**Mitigated Negative Declaration for the Proposed Street Light
Replacement for Areas 3–5B Project
City of Riverside**

**City of Riverside
Community & Economic Development Department
Planning Division**

P-3 COMMENTS AND RESPONSES TO COMMENTS

INTENTIONALLY LEFT BLANK

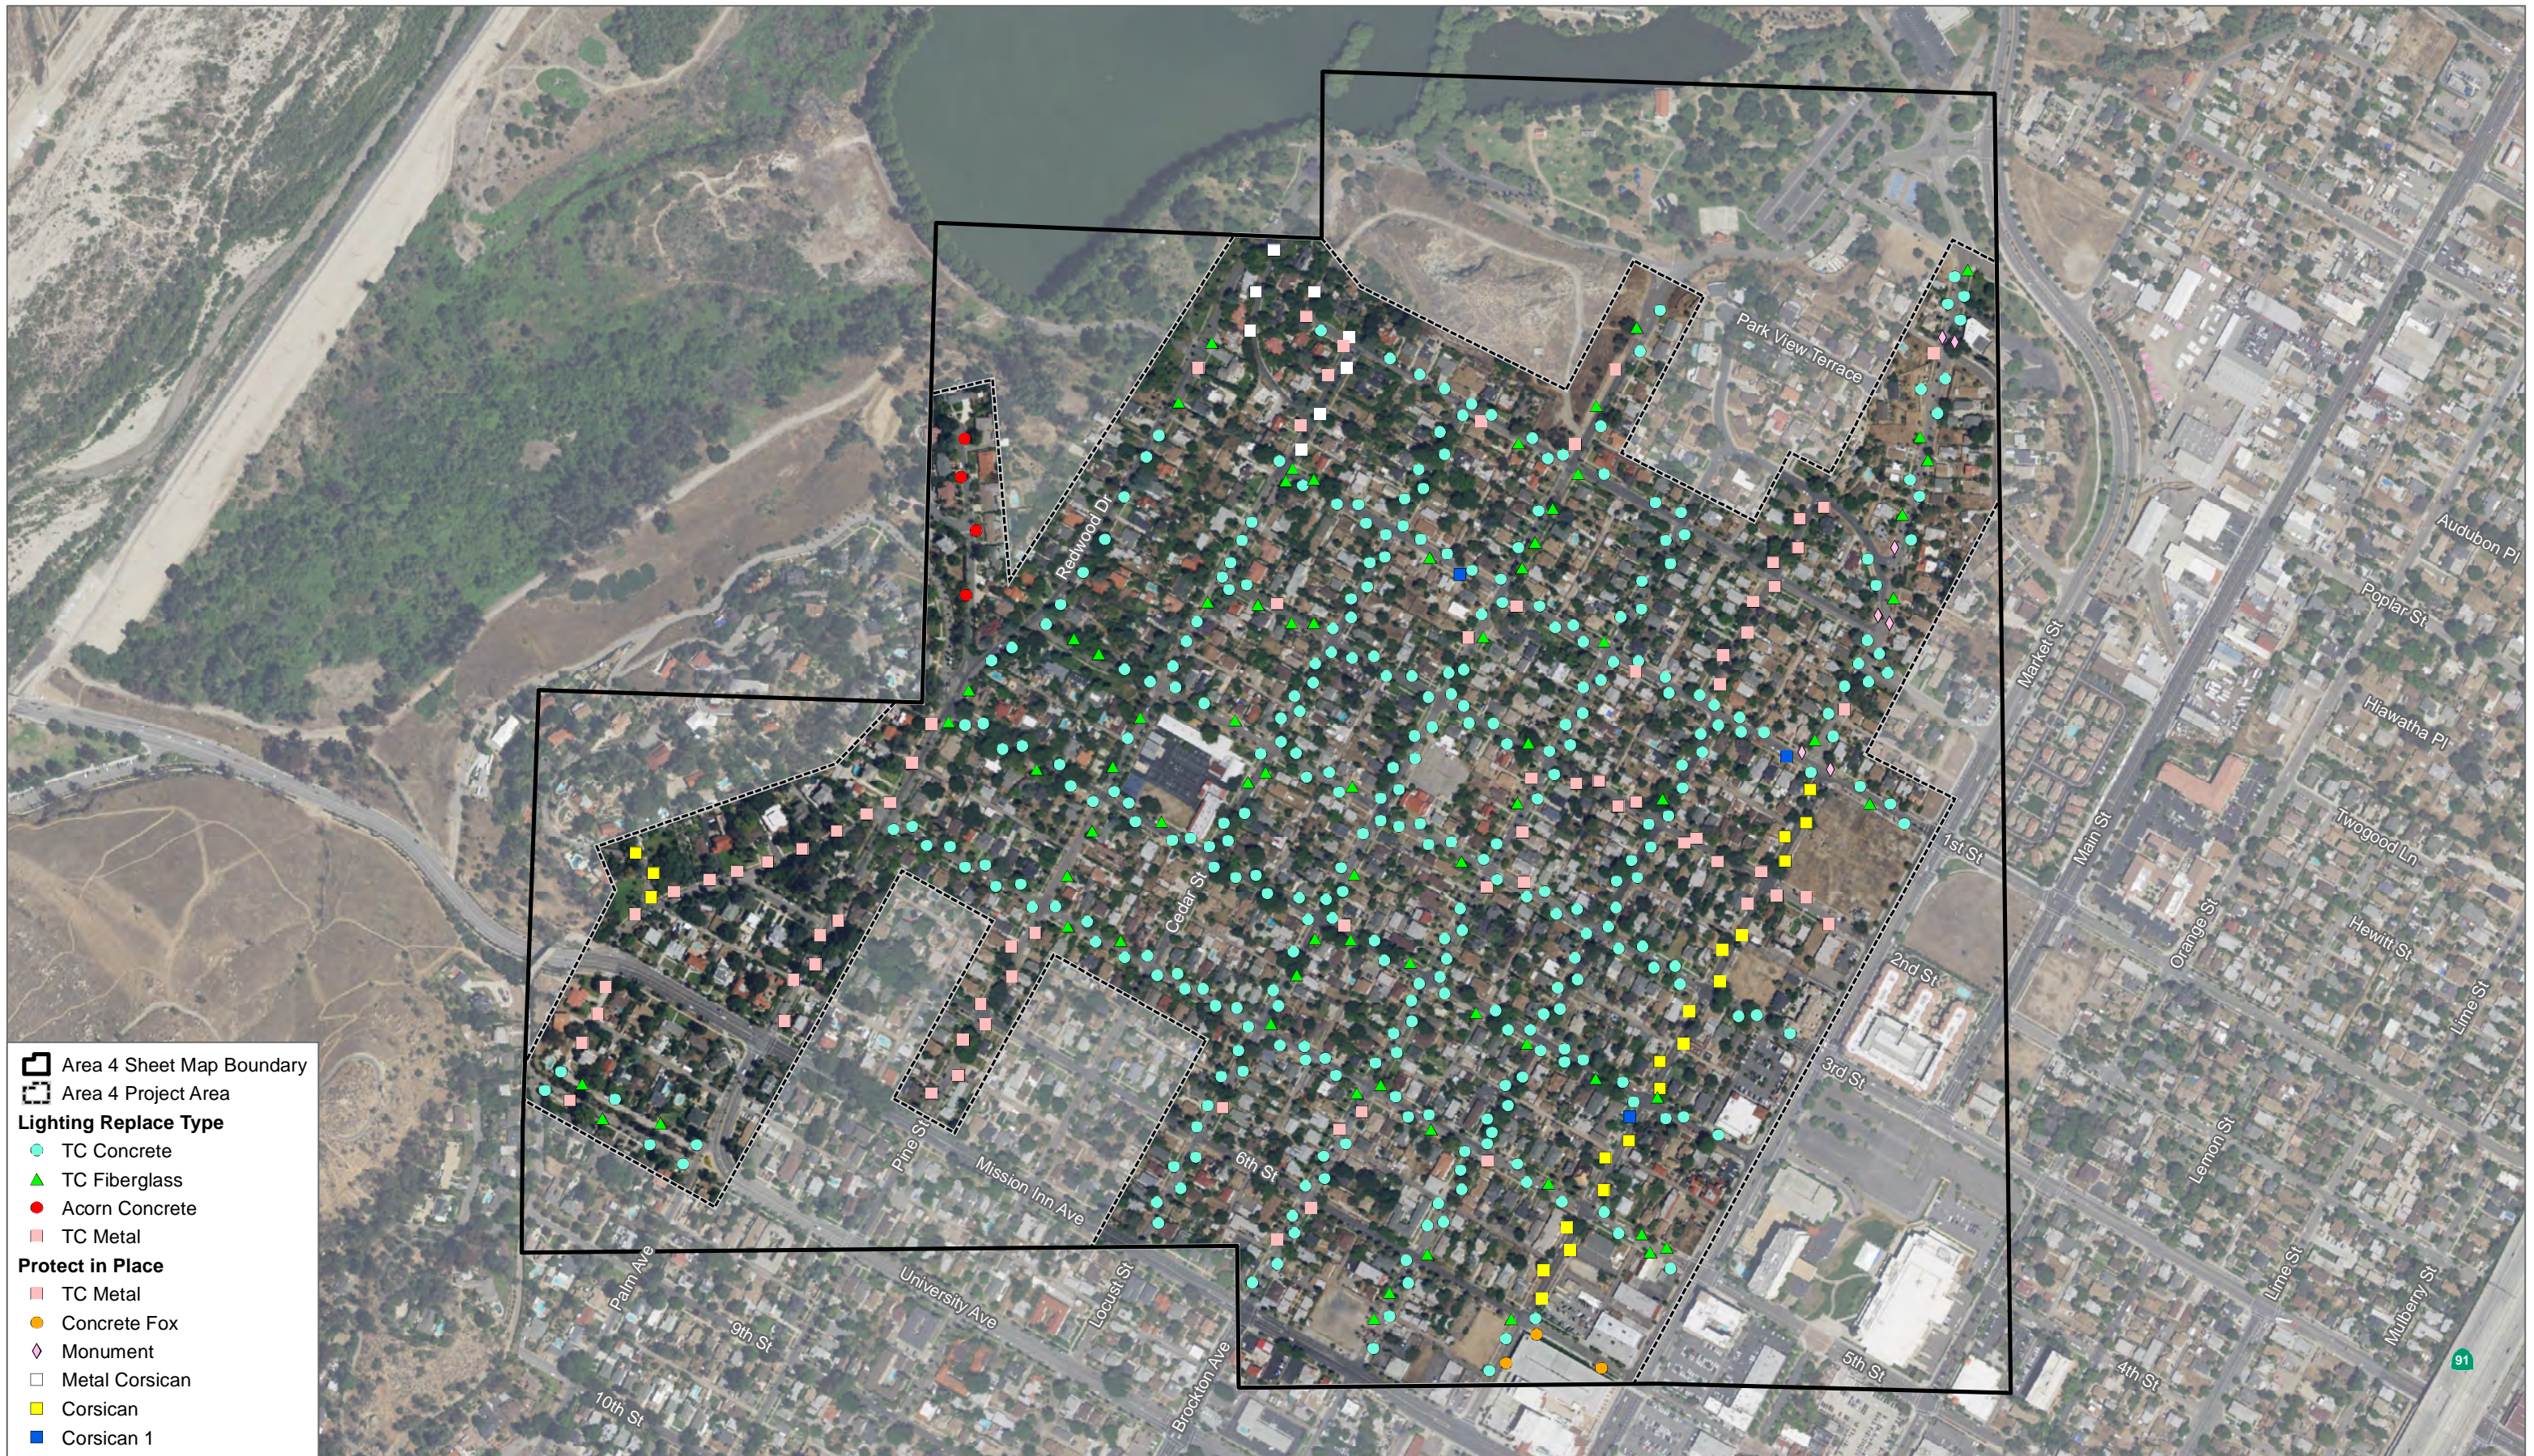
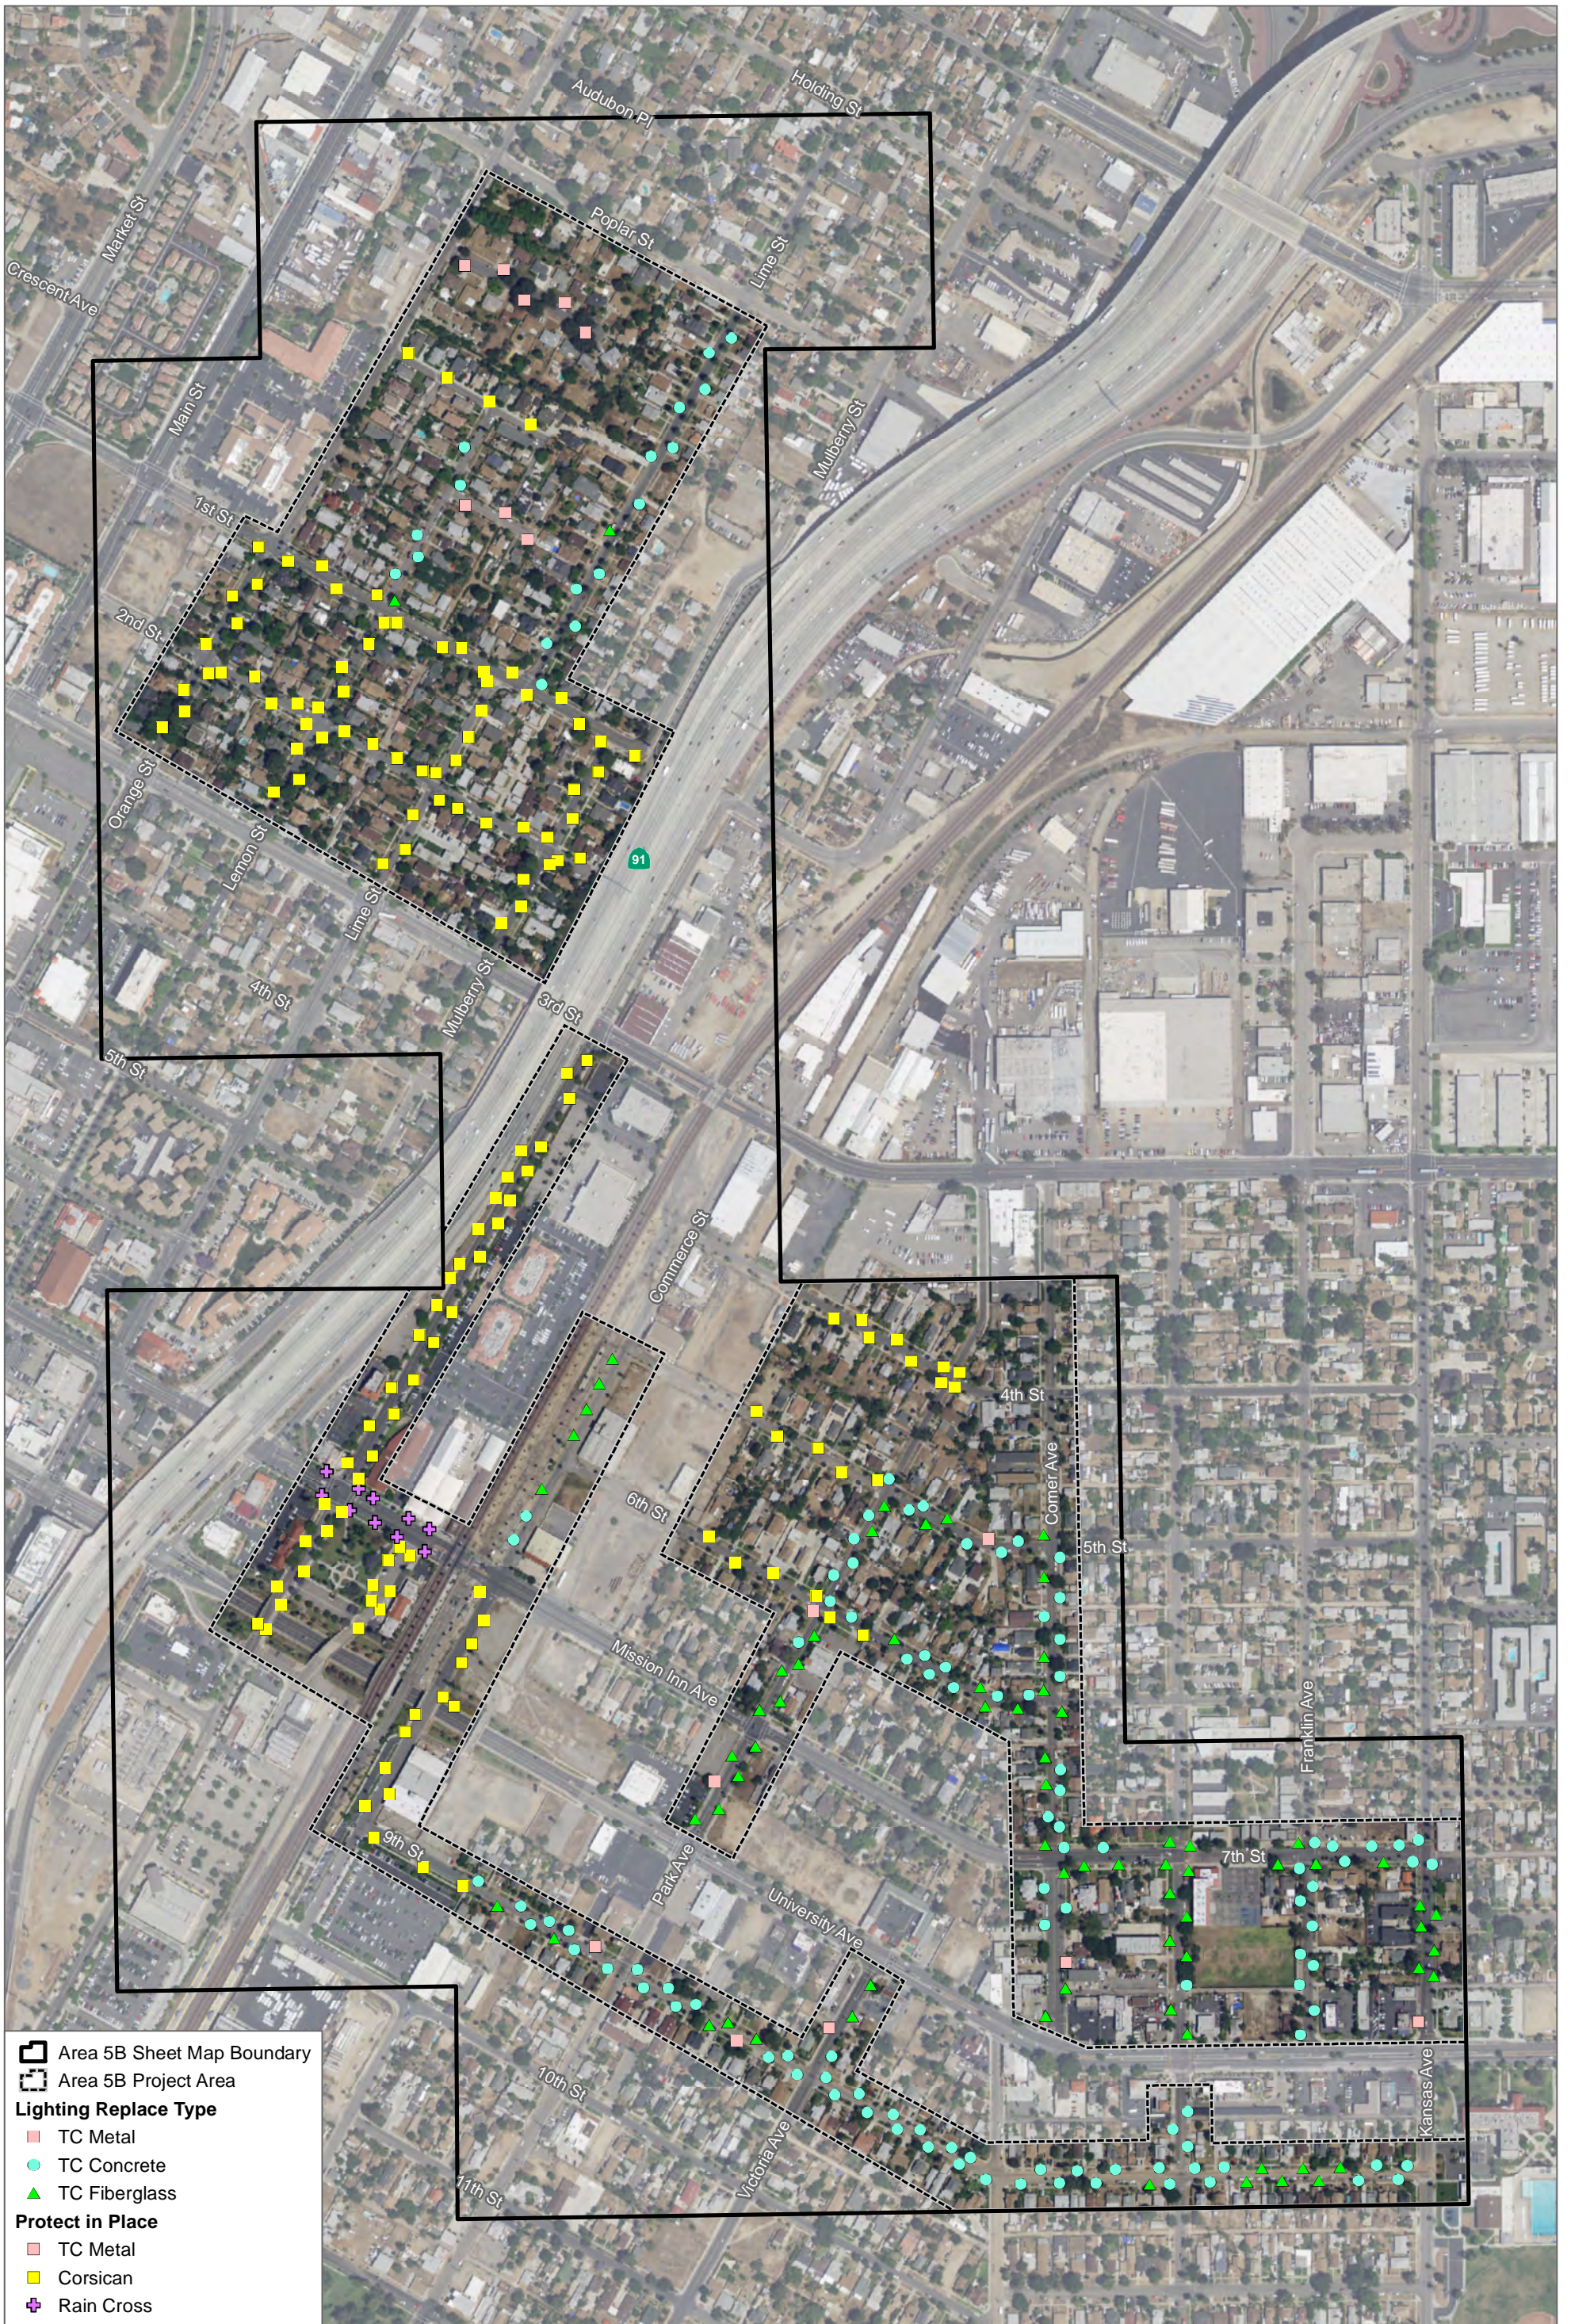
- A-1** The commenter expresses concern regarding the height and location of the proposed streetlights, and potential impacts this may have on airplane hazards. Figures 3 through 7, included in the IS/MND, show all locations where the streetlights would be replaced. As discussed in IS/MND Section 4.2.5a, the proposed number and spacing of streetlights is based on American National Standard Practice for Roadway Lighting ANSI/IESNA RP-8 (RP-8), the standard approved by the Riverside City Council in 1996. As advances in lumen output technology have been made since installation of the existing historic streetlights, RP-8 Standards would actually reduce the number of streetlights needed per block to provide required lighting levels. Thus, the proposed project is expected to result in fewer streetlights than currently exist in Areas 3 through 5B. Provisions of the City's historic preservation ordinance, Title 20, the Secretary of the Interior's Standards for the Treatment of Historic Properties related to historic resources and design standards and guidelines, require that replacement streetlights look similar to existing ones. Thus, it is expected that replacement streetlights would be similar in height to existing streetlights. More specifically, the design details of the proposed replacement streetlights, including the proposed height of the streetlights, have been incorporated as Figure P-1, Replica Kodiak Replacement Streetlights Details, and the design details of the proposed luminaires have been included as Figure P-2, Proposed Luminaire Details. As shown in these figures, the standard and luminaire, together, indicate a total installed height of 14 feet and 3.5 inches. It should be noted that the height of the proposed replica streetlights is approximately 2 inches taller than existing streetlights. However, the existing direct embedment historic streetlights currently vary in height for a variety of reasons, such as the depth of the original excavation at the time of installation, soil compaction, minor changes in parkway elevation due to landscaping changes, settlement, and intrusion by tree roots. It should also be noted that although not all the streetlights would be replaced in the exact same location as the existing streetlights, replacements would be made in the same general locations (either adjacent to or across the street from existing streetlights). Further, the proposed streetlights are not expected to exceed the heights of other structures in the areas, including two- to three-story existing structures in the area, telephone poles, palm trees, etc. Lastly, as discussed in Section 4.2.8d, although part of the project site is located within Compatibility Zone "Other Airport Environs" of the Riverside Municipal Airport, only uses that would be hazardous to flight (such as tall structures) are prohibited within this zone.. The City provided additional information regarding the height and location of the proposed streetlights to the commenter on October 3, 2018, and November 1, 2018.
